Re-submittal Form

September 22, 2021

Re: Clear Creek Valley (Previously TTLC Denver – Lowell) – 2nd Review Comments
Project Number: PRC2021-00002

6' DOUBLE-SIDED WOOD FENCE

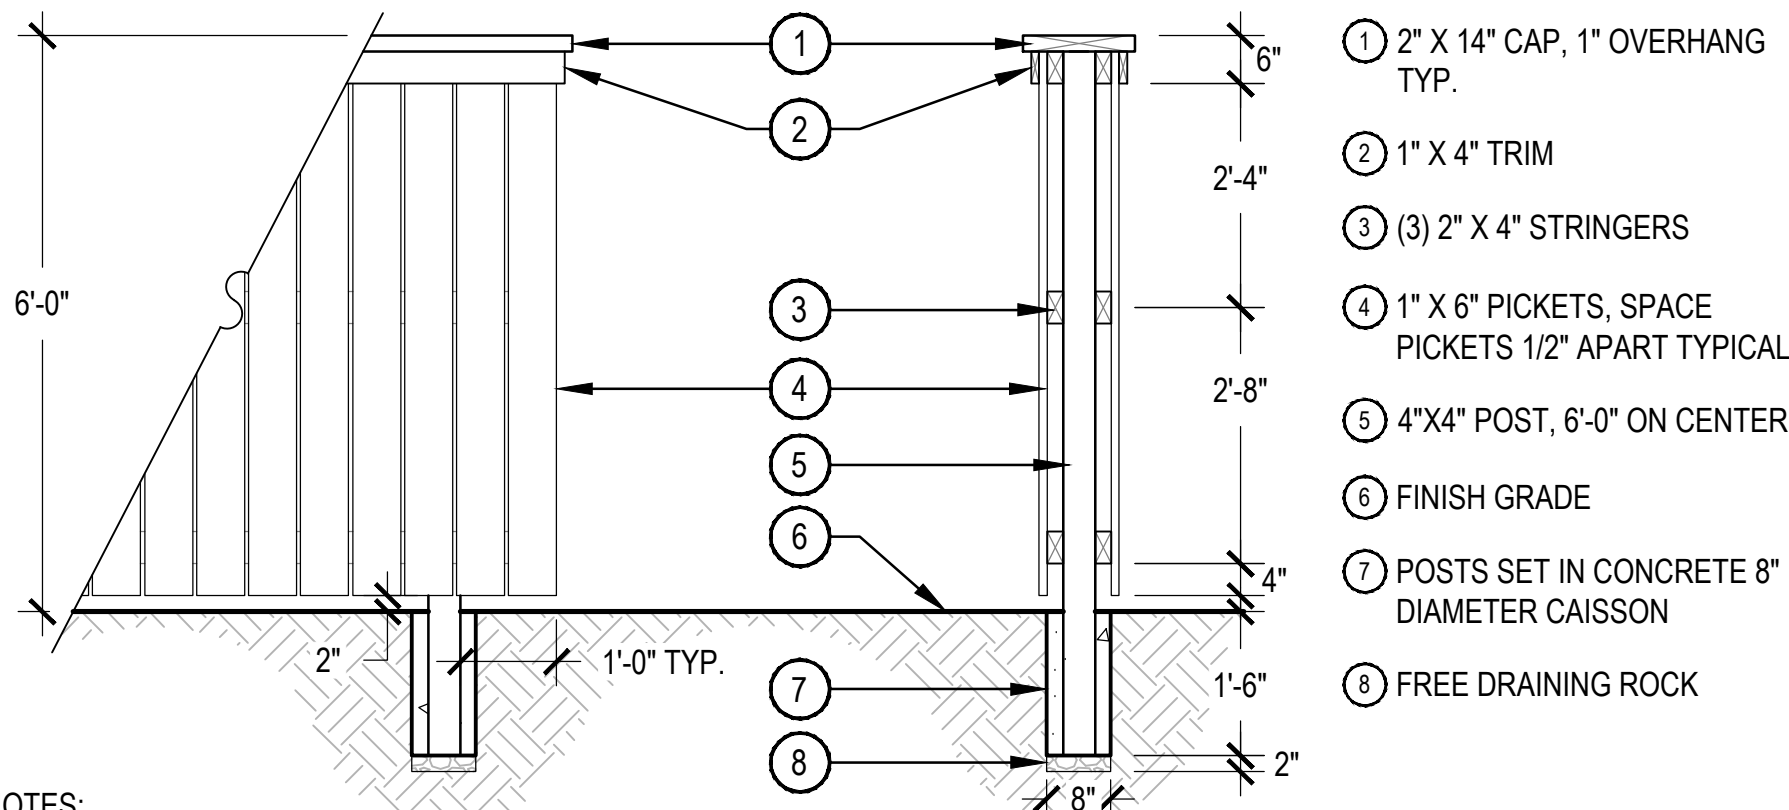
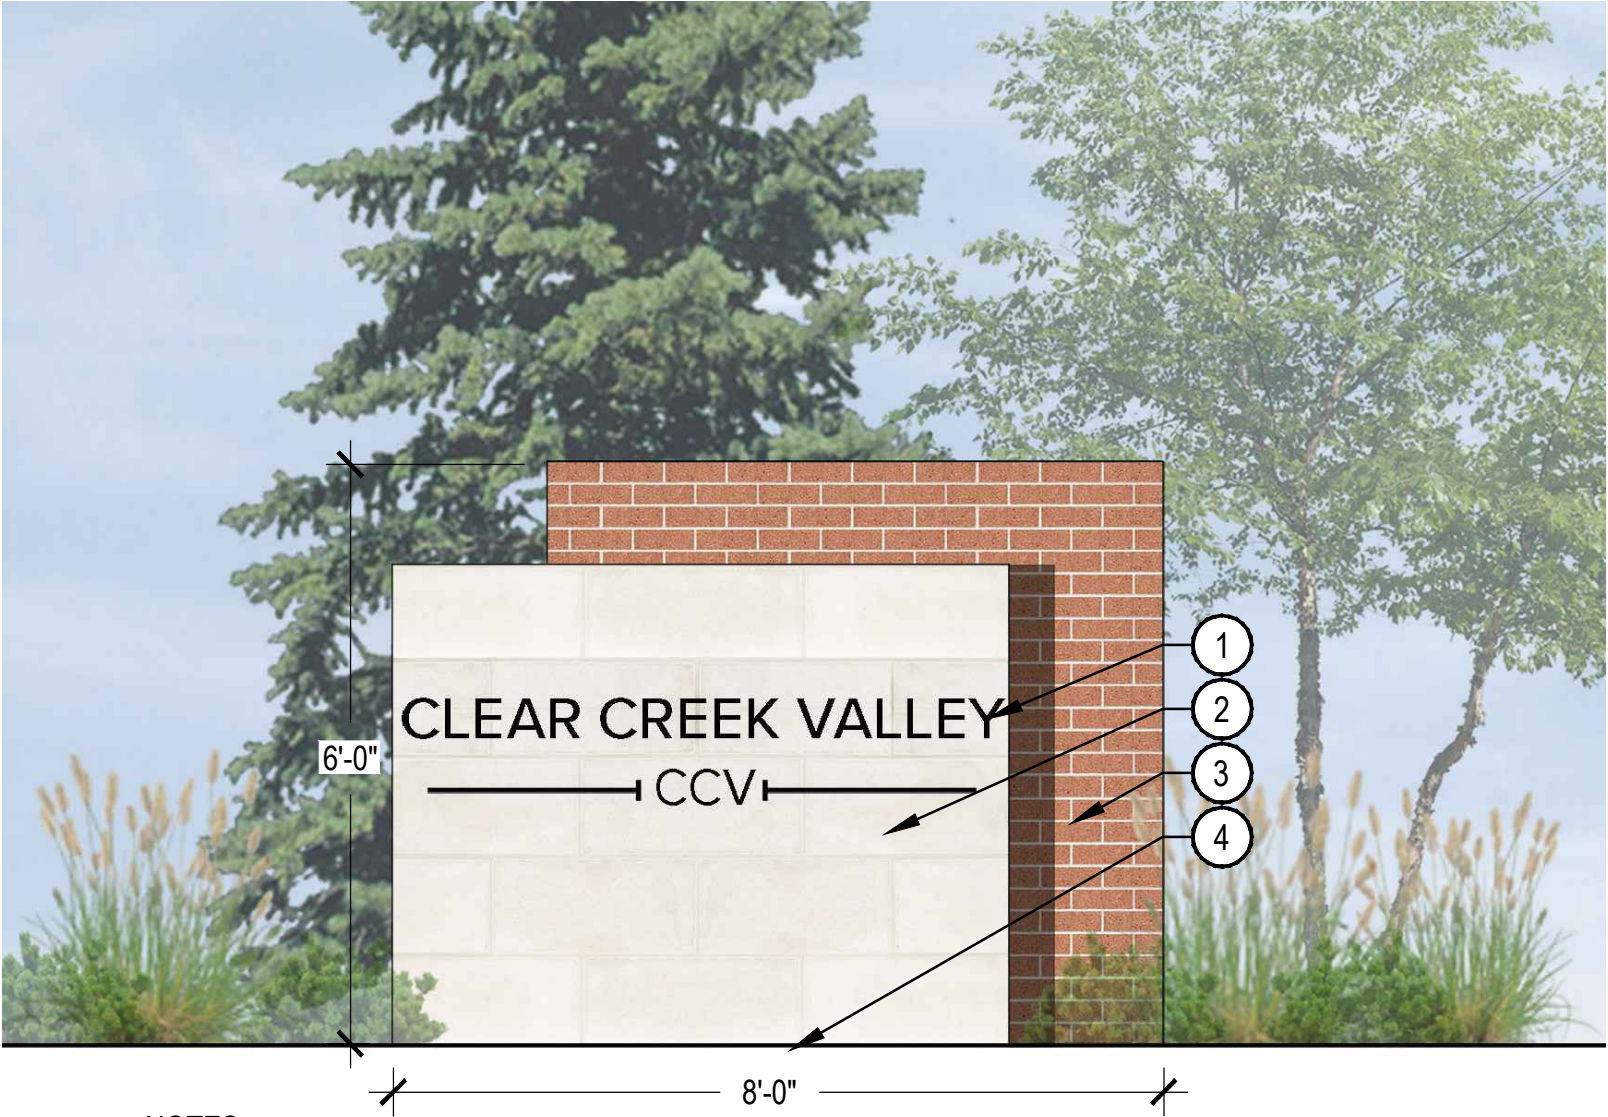
3. Fencing- More detail on materials and location must be included in the PDP. The County does not enforce HOA approval and Staff needs the information to review and approve/deny fence permits as they are applied for. Again, you can include a note that it is subject to change at FDP, however it must be outlined during the PDP stage.

Response: Two detailed fencing details have been provided in this PUD/PDP.
4. Accessory Structures- More detail must be included in the PDP. The County does not enforce HOA approval and Staff needs the information to review and approve/deny accessory structure permits as they are applied for. Again, you can include a note that it is subject to change at FDP, however it must be outlined during the PDP stage.
